RE: Preliminary Zoning Proposals - Draft Housing Element 6th Cycle (2023-2031)

Preliminary Zoning Proposals

Figure 1: Existing Residential Density, Central and North Oakland Inset (from Oakland Map Atlas, Figure 2-6)

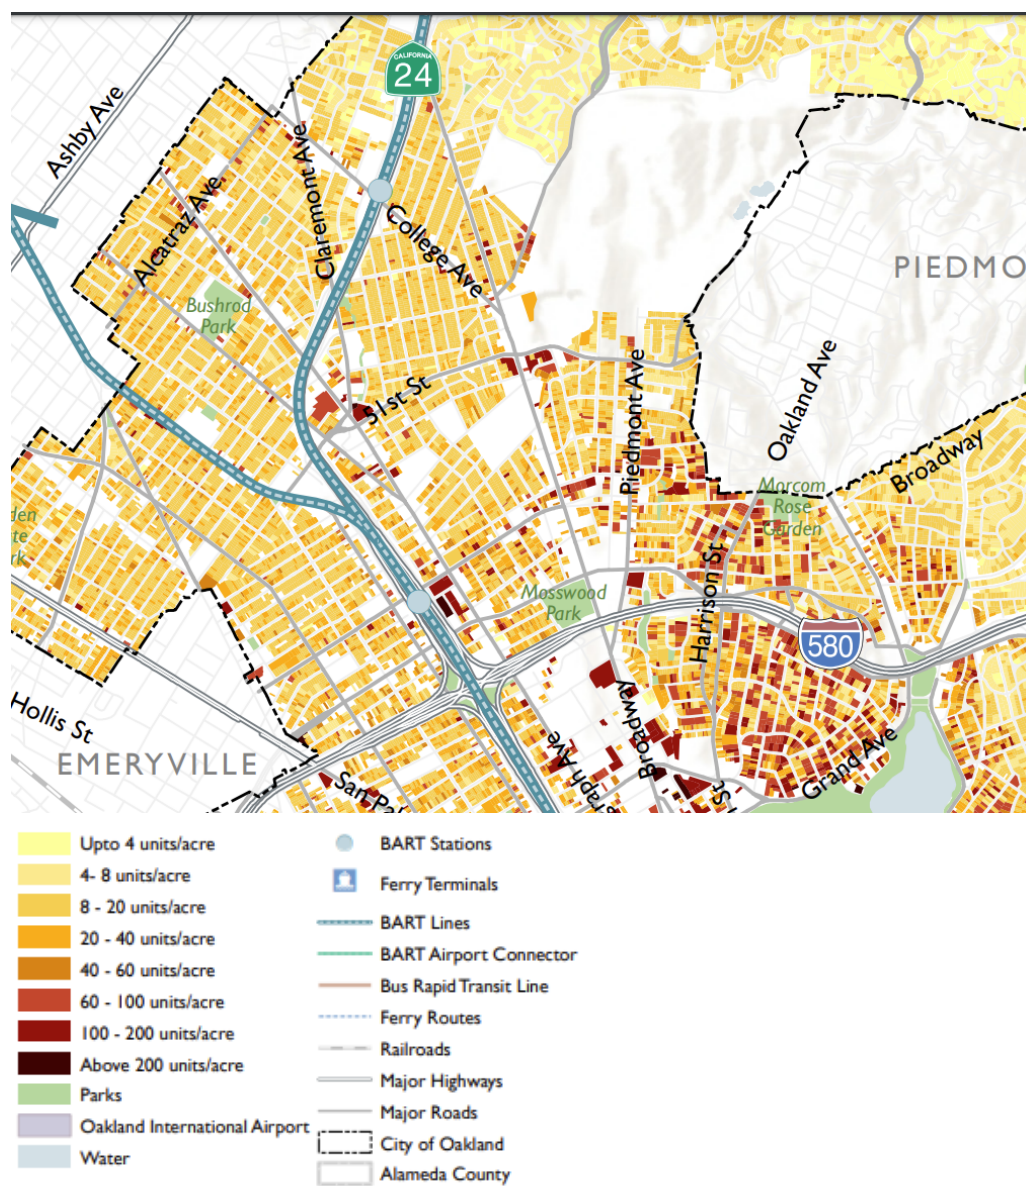
- Adams Point: The zoning map shows a rezoning of the center of Adams Point from RM-1 to RM-2. This neighborhood is already full of medium-sized apartment buildings (see Figure 1 below, taken from the Oakland Map Atlas) These zoned capacity should match the existing built environment to allow for 4-8 story apartments. Alternatively, consider rezoning this area to RM-4.

- High Resource Areas: Bushrod, Santa Fe, Trestle Glen, Crocker Highlands are all high-resource or moderate-resource areas that are untouched by the proposed Missing Middle Program rezonings. These are also low-VMT neighborhoods with easy non-car access to jobs, parks and schools. They should be rezoned to at least RM-2. (Also in Figure 1 below).

- the triangle of Adams Point in the lower right of the figure is already densely full of medium- and some large apartment buildings - the densest census tracts in Oakland outside downtown - yet is mostly zoned RM out of keeping with its current environment, and the proposed rezonings only move a small chunk of it up one level within RM. It should be a high-density zoning designation that allows the same buildings that exists now - not RM or even RU.
- Rockridge, Temescal, and other parts of North Oakland are nearly a single-family monoculture, while the proposed rezonings only increase the density in that large, high-opportunity by a small degree.
